STATE OF CONNECTICUT CONNECTICUT SITING COUNCIL

DOCKET NO. 415

RESPONSES OF CELLCO PARTNERSHIP d/b/a VERIZON WIRELESS TO CONNECTICUT SITING COUNCIL PRE-HEARING INTERROGATORIES

TAB 1

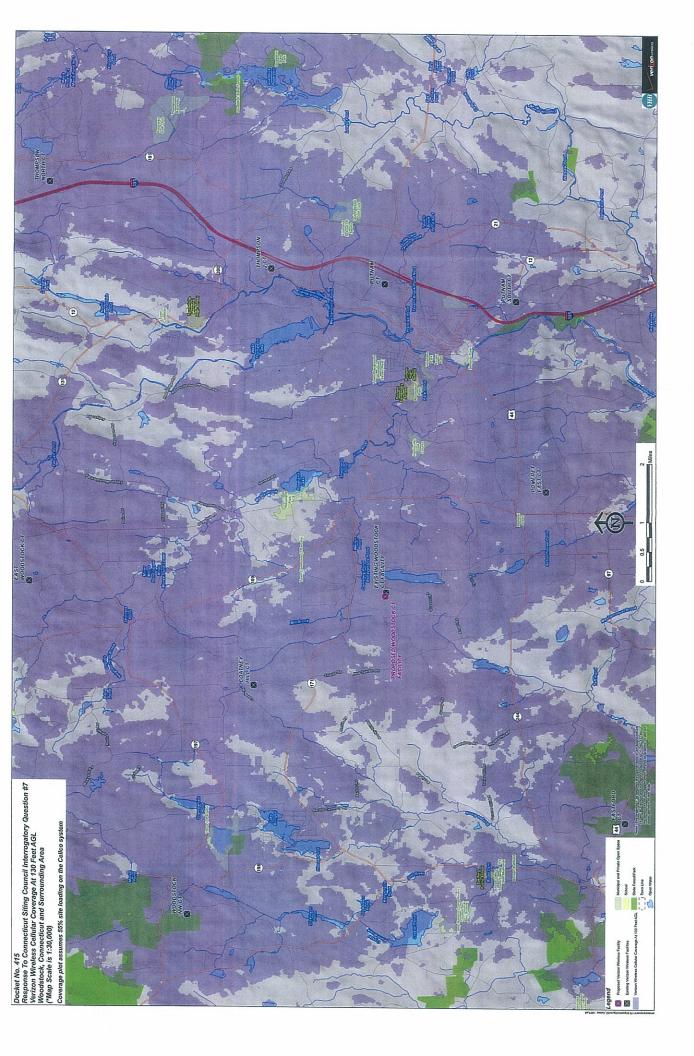
Provide a coverage plot, using the scale and thresholds in Application Attachment 6, that depict coverage from existing/approved Cellco sites and the proposed tower at a height of 130 feet (Cellular and PCS).

Plots showing coverage from Cellco's cellular and PCS antennas on the proposed Woodstock Facility tower at a height of 130' are included in Attachment 1. At cellular frequencies, the 20' drop in antenna centerline height results in gaps opening up along portions of Route 169 and a reduction in the overall coverage footprint at the site from 14.8 to 14.1 square miles. At PCS frequencies, the 20' drop in antenna centerline height results in gaps opening

along portions of Route 171 and Route 169 and a reduction in the overall coverage footprint at the site from 7.5 to 7.2 square miles.

TAB 2

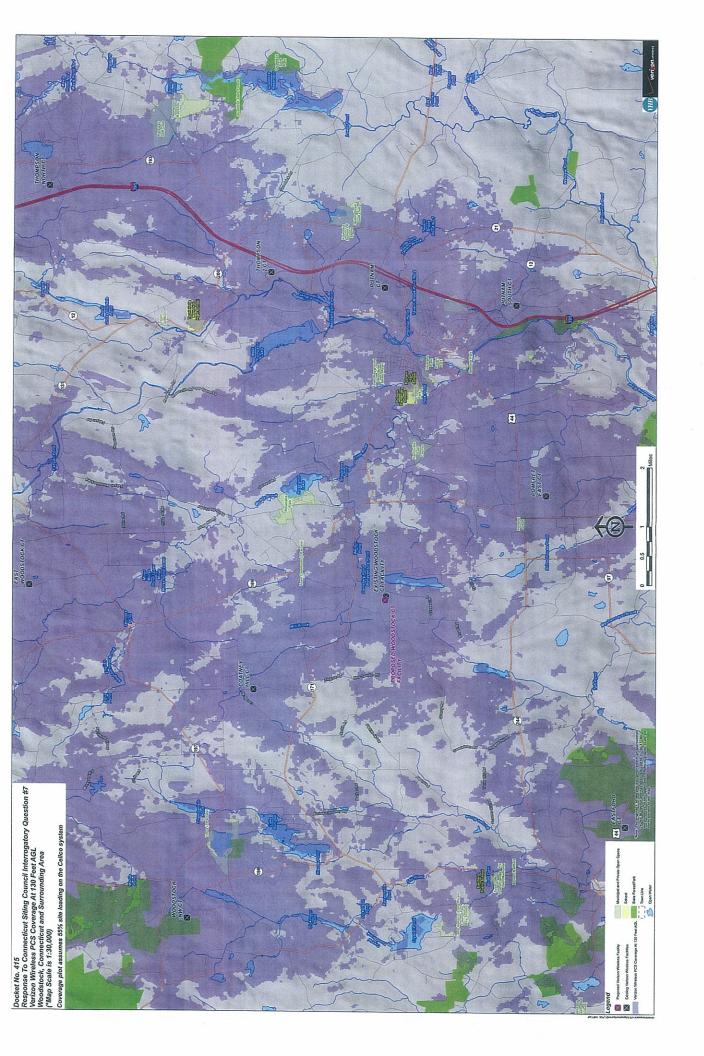
Is the site within the *Quinebaug-Shetucket Rivers National Heritage Corridor*? If so, describe the impact of the proposed facility on resources within the heritage area.

According to the Siting Council's telecommunications databases, there are at least 100 towers located in the 26 Connecticut communities within the National Heritage Corridor, including those used for emergency service providers, radio and television broadcasts, private dispatch, and wireless telecommunications. In the Town of Woodstock, there are at least five existing facilities of this nature. See The Last Green Valley map included in Attachment 2 of these responses.
